IMPORTANT SAFETY RECALL**P07 / NHTSA 14V-100**

Chrysler has decided that some **2014 model year RAM 5500 trucks** fail to conform to Federal Motor Vehicle Safety Standard (FMVSS) No. 567 – Certification.

Installation Instructions for Certification and Tire Pressure Labels

Figure 1 – Four Door Model Shown

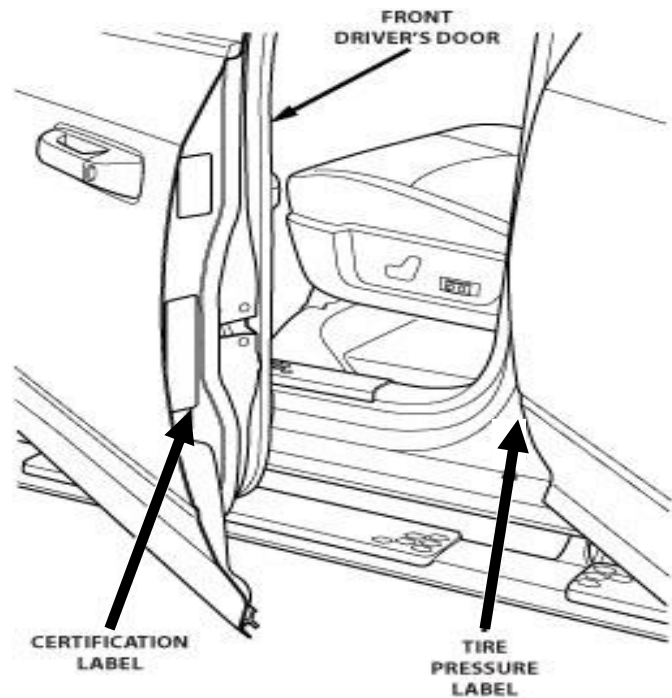
The problem is... **The Certification and Supplemental Tire Pressure Information label on your truck fail to conform to the requirements of Federal Motor Vehicle Safety Standard (FMVSS) No. 567, “Certification”. The labels contain incorrect vehicle weight rating and incorrect payload value on the supplemental tire pressure label. This can cause improper loading of the vehicle and cause a crash without warning.**

What you must do to ensure your safety... ➤ **We ask that you apply the enclosed Certification label and Supplemental Tire Pressure Information label so that they cover the existing labels as described on the reverse side of this letter.**

1. Open the driver's door and locate the Certification label on the driver's door as shown in Figure 1.
2. Clean the existing Certification label with alcohol / glass cleaner or equivalent and a soft cloth to remove any dirt, oil residue or grease.
3. Remove the enclosed Certification label from its paper backing and carefully install it over the existing Certification label (Figure 1). Firmly press and smooth the label to the surface of the existing Certification label to ensure good adhesion.
4. Locate the Supplemental Tire Pressure Information label on the driver side B-post above the door striker as shown in Figure 1.

5. Clean the existing Supplemental Tire Pressure Information label with alcohol / glass cleaner or equivalent and a soft cloth to remove any dirt, oil residue or grease.
6. Remove the Supplemental Tire Pressure Information label from its paper backing and carefully install it over the existing label (Figure 1). Firmly press and smooth the label to the surface of the existing Supplemental Tire Pressure Information label to ensure good adhesion.
7. Fleet companies requiring Incomplete Vehicle Documentation (IVD) labels are required to call 1-866-726-4636 to request the labels. Please provide a name and address when requesting IVD labels. The labels will be mailed overnight.
